I wish to add to my written statement.

Insufficient consideration has been given to the history of flooding in Sutton on Trent and Carlton on Trent, and no consideration at all of studies into the impact of solar panels on surface water run-off, particularly the difference between cross-slope and along-slope panel orientation (e.g. <https://onlinelibrary.wiley.com/doi/full/10.1002/hyp.15053>).

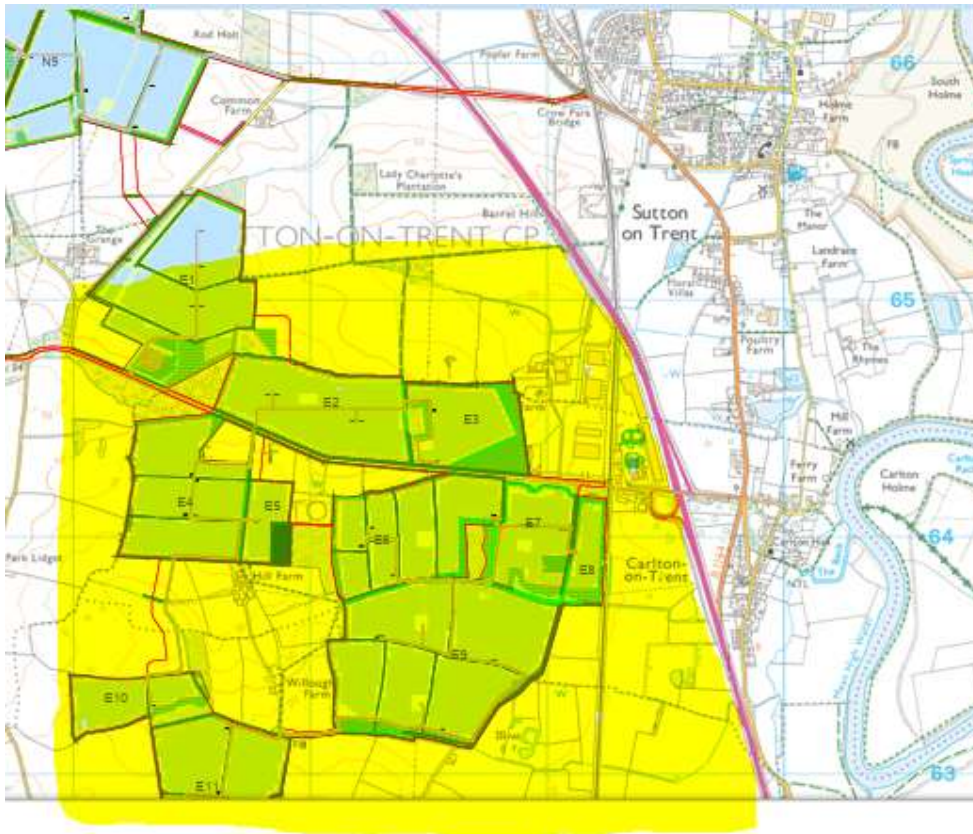
The fields immediately west of Carlton on Trent (highlighted below) drain directly towards the River Trent via Carlton and Sutton villages. Any alteration to these fields **will** directly affect residents of both villages.

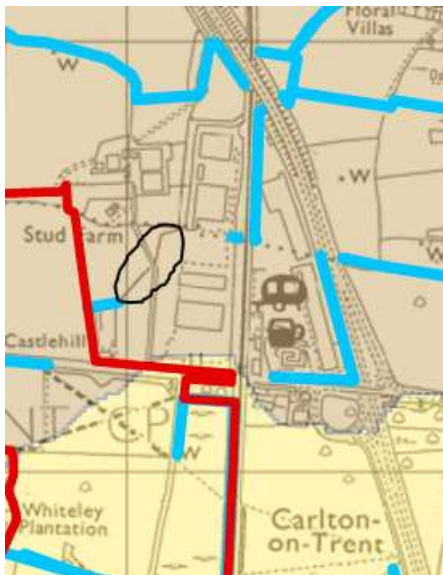
The watercourse mapping (EN010162-000068-GNR\_2.6\_Water Bodies) is incomplete. The dyke continuation identified below is identical in character and function but is not marked. Reliance on desk-top data has clearly led to inaccuracies that undermine the flood risk assessment.

Drawing EN010162-000015-GNR\_5.6 (Design Approach, Part 2 of 4) confirms the vast majority of panels near Carlton are oriented perpendicular to contours. This is one of the most concentrated panel areas in the entire scheme with many adjacent fields covered, magnifying cumulative impact.

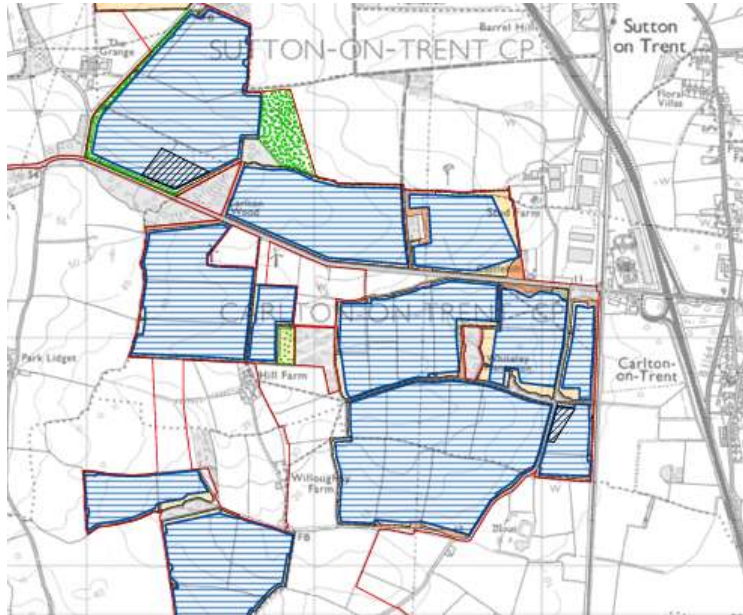
I suggested during consultation that the steepest fields be left panel-free, that some fields be excluded to reduce concentration, that row spacing be increased, and that a large retention basin be created. None of these measures appear in the application for the Carlton area.
